# ADDENDUM NO. 8

Date: July 31, 2018

## Health Center–Concessions and Parking Lot Phase 1A Irvine Valley College

**Bid No. 350**

**Addendum 8 - Attachment 8B**

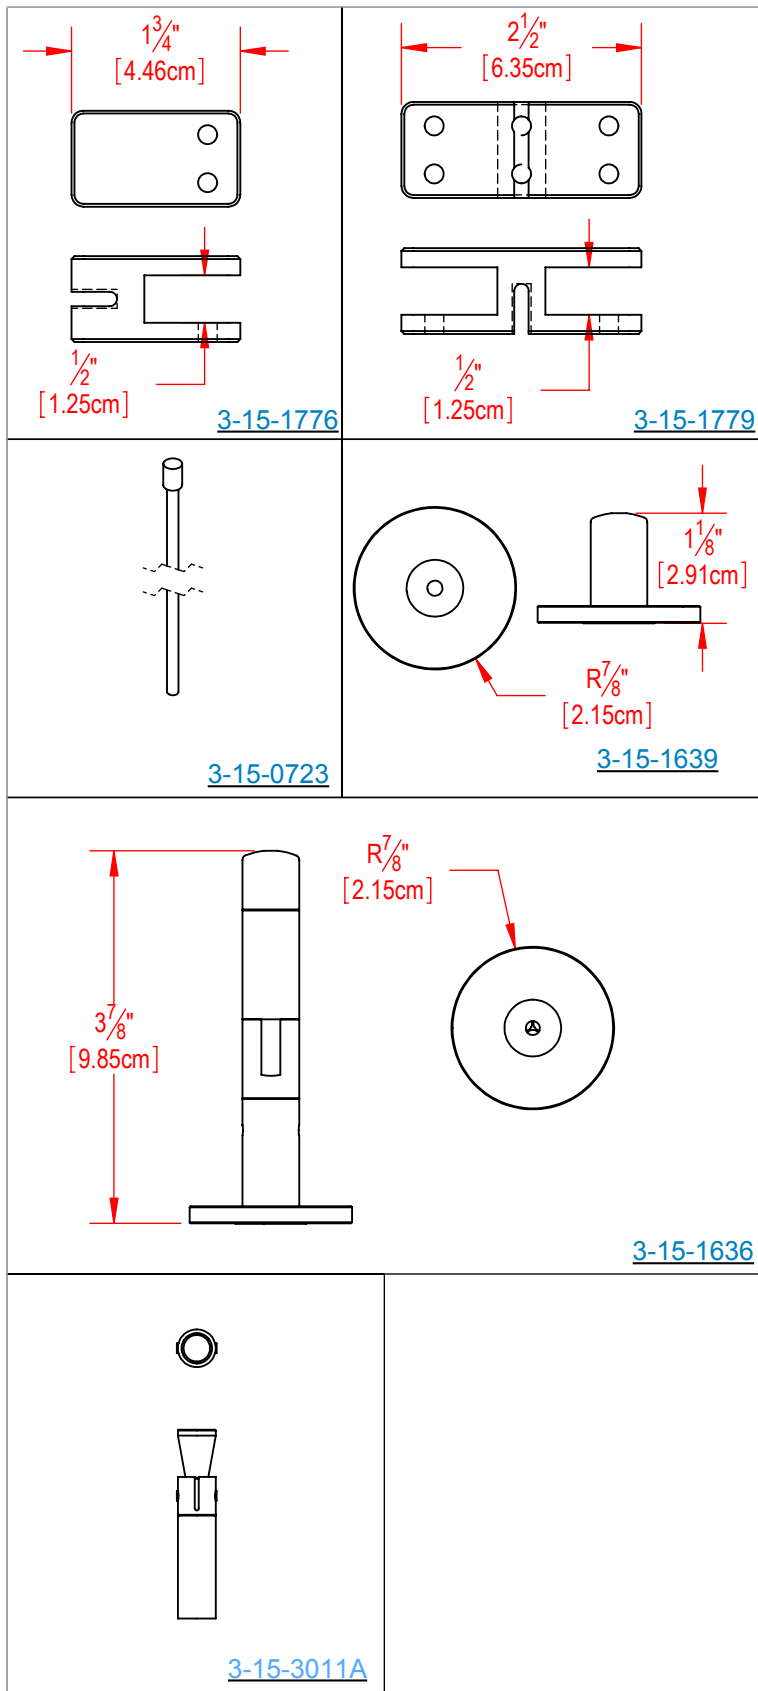
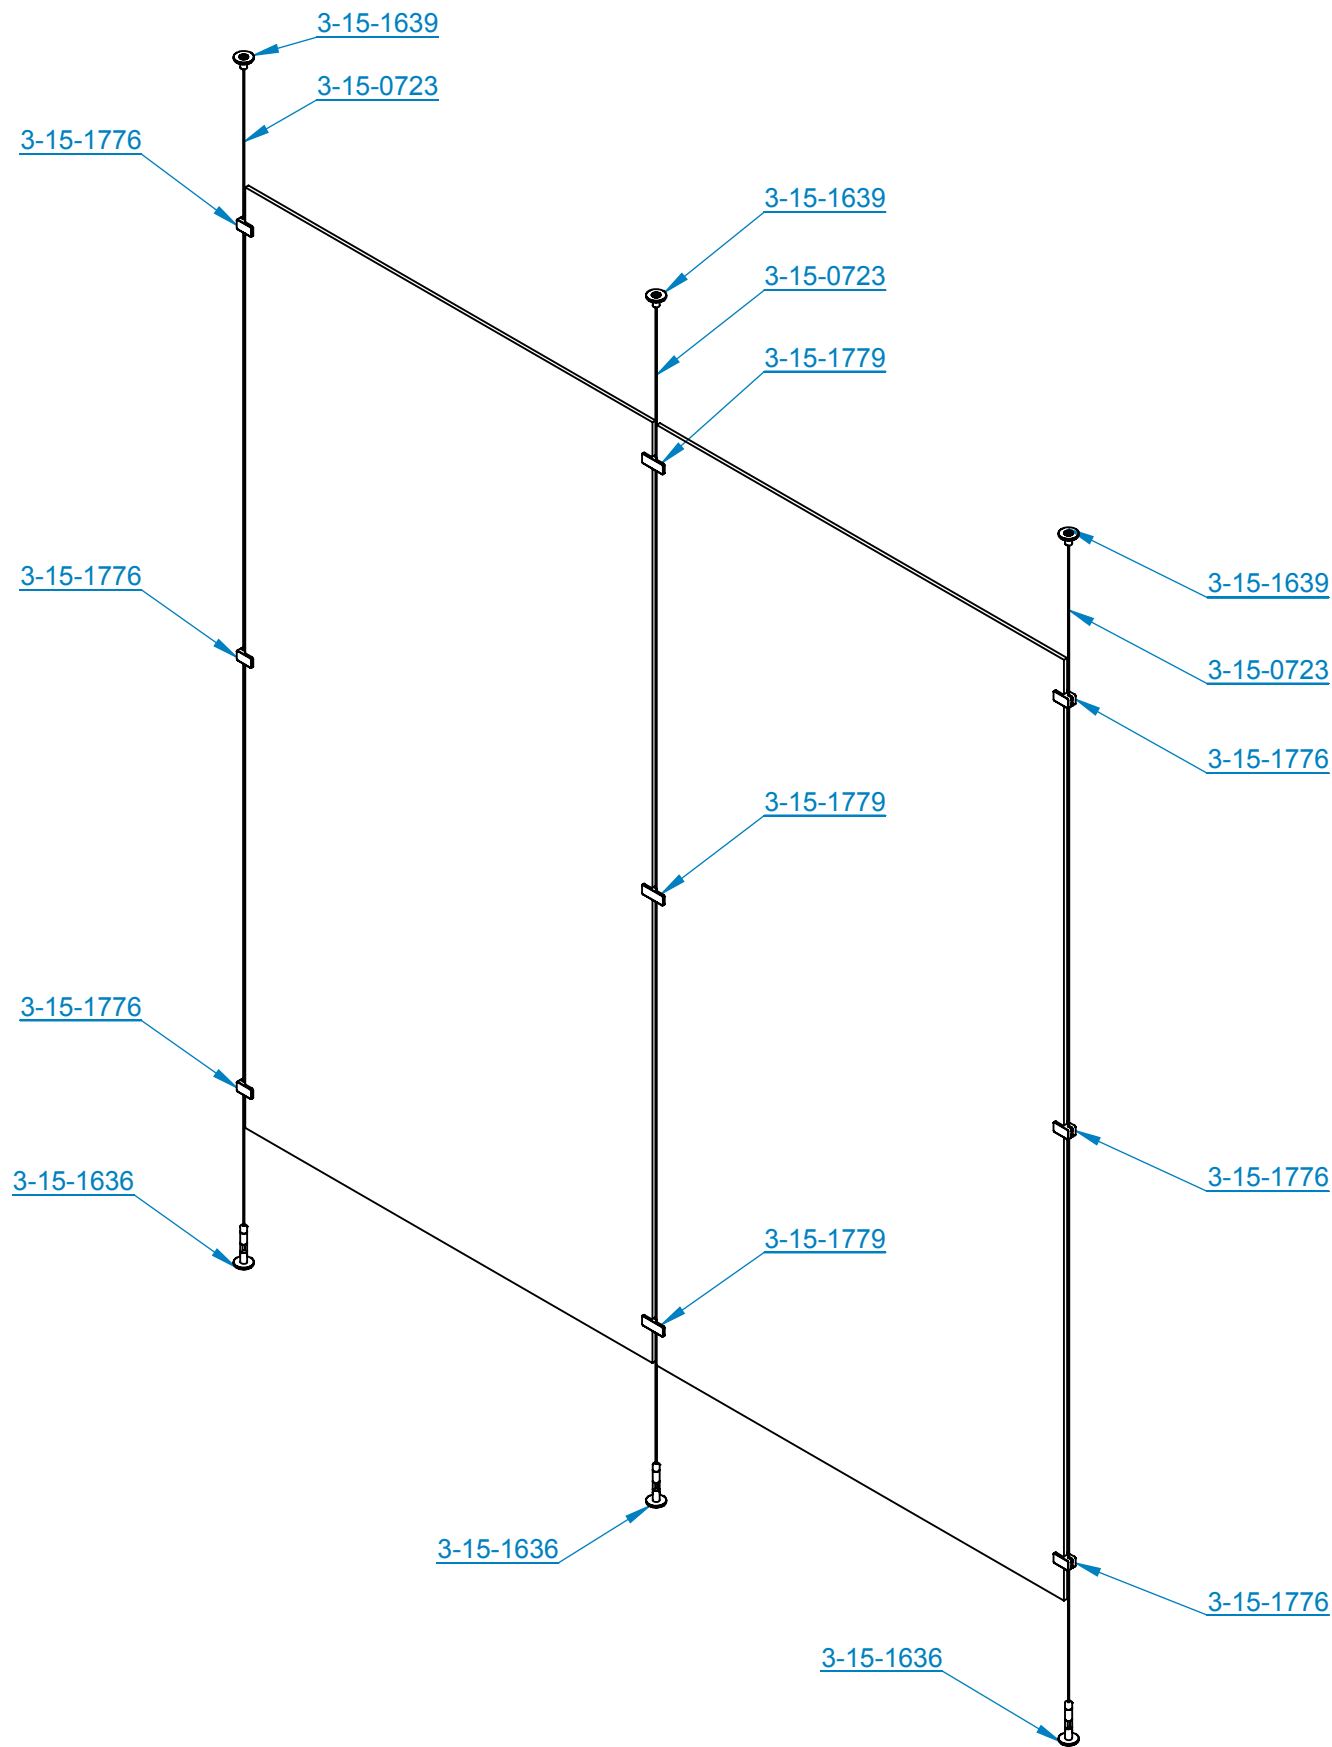
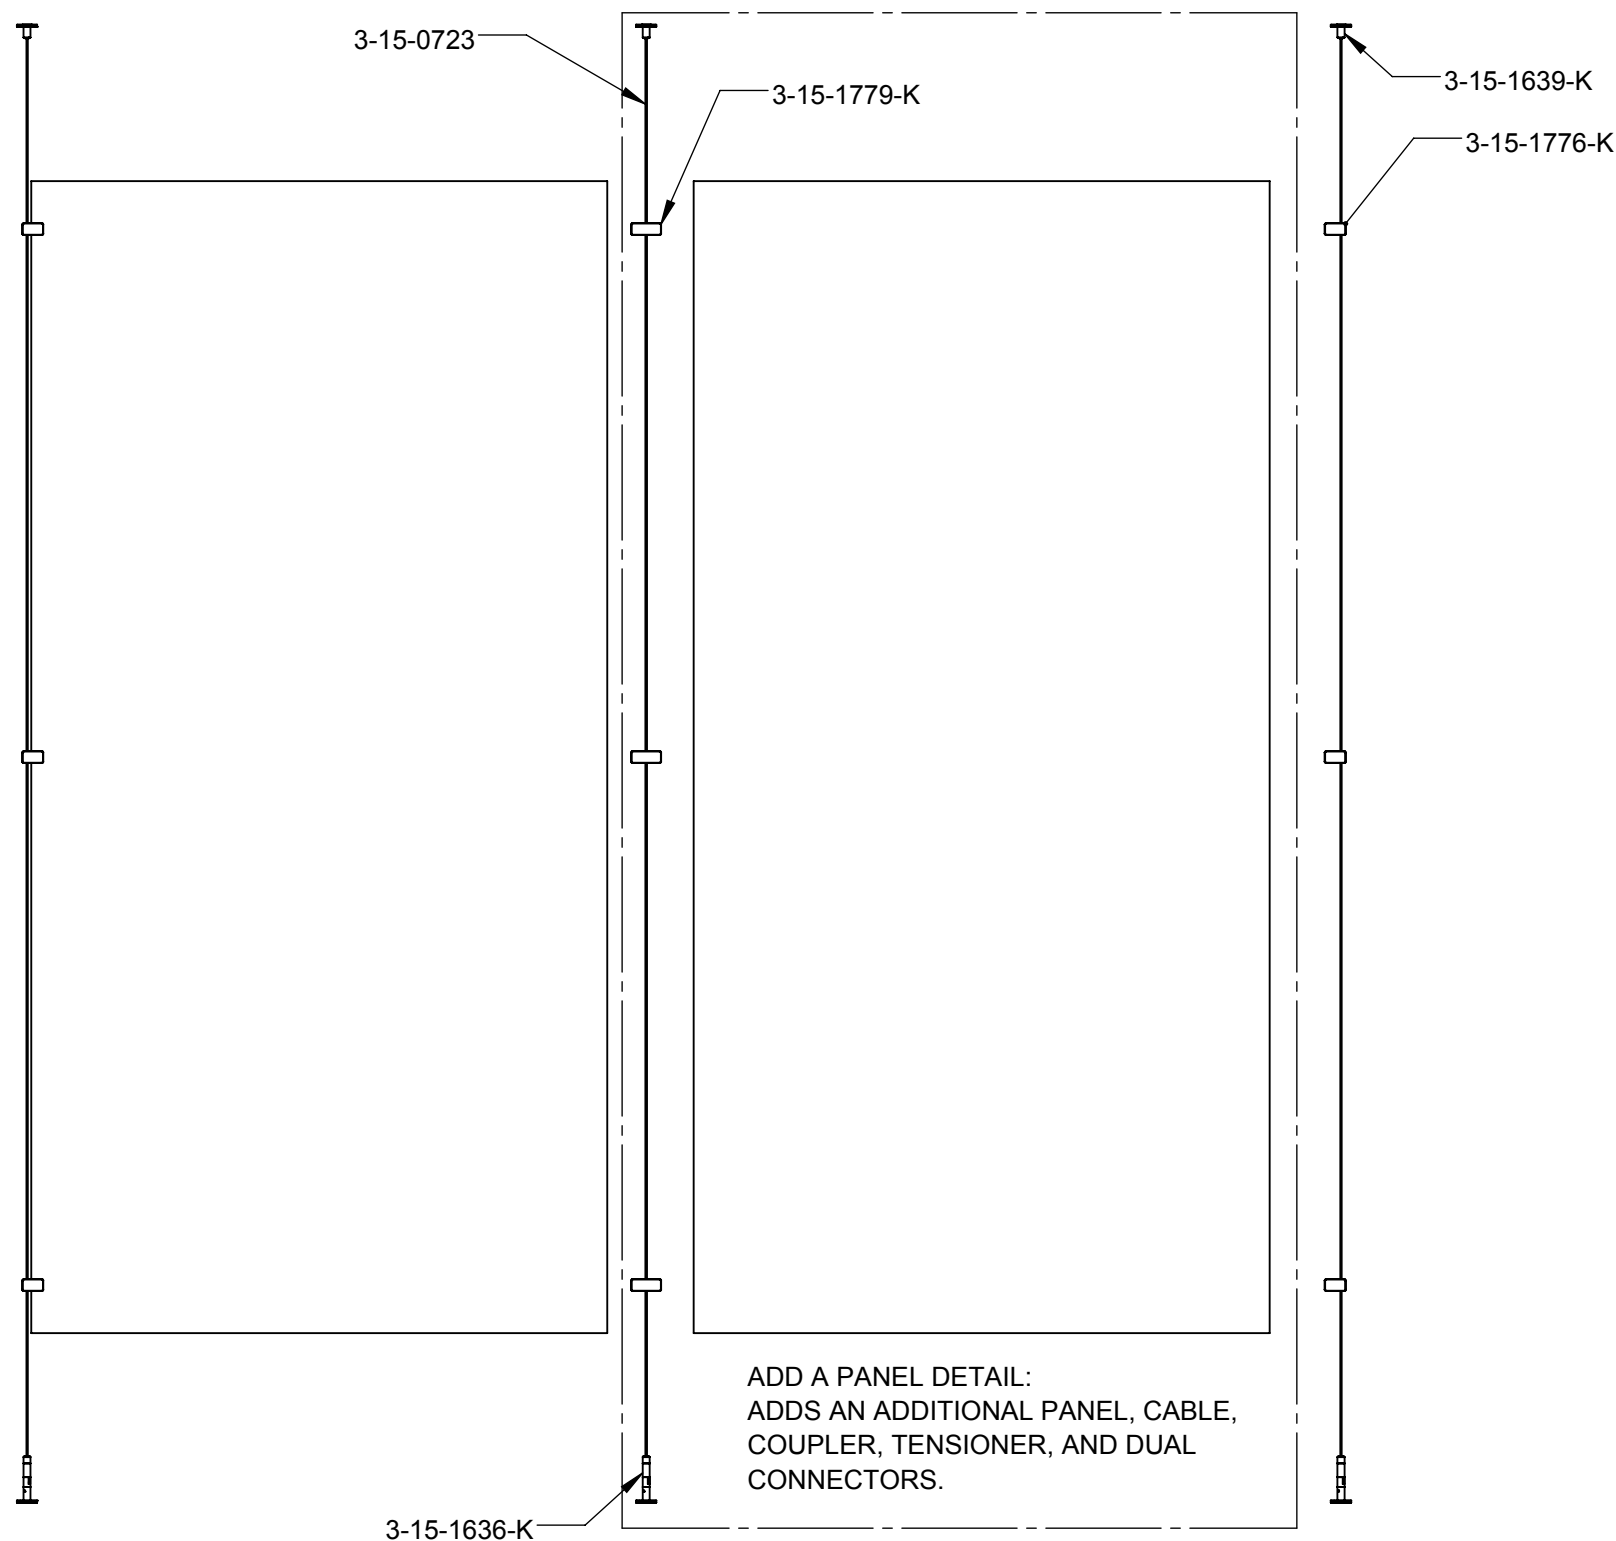
Q3: Please clarify the hardware specified for the Reception/Check-In laminated glass opening into the Waiting Area.

A3: Reception counter glass shall be 3/8-inch laminated glass per Section 08 81 00 with 3form (or equal) stainless steel patch hardware. Provide shop drawings for review and approval prior to fabrication and installation. Data sheet for 3form hardware is attached for reference.
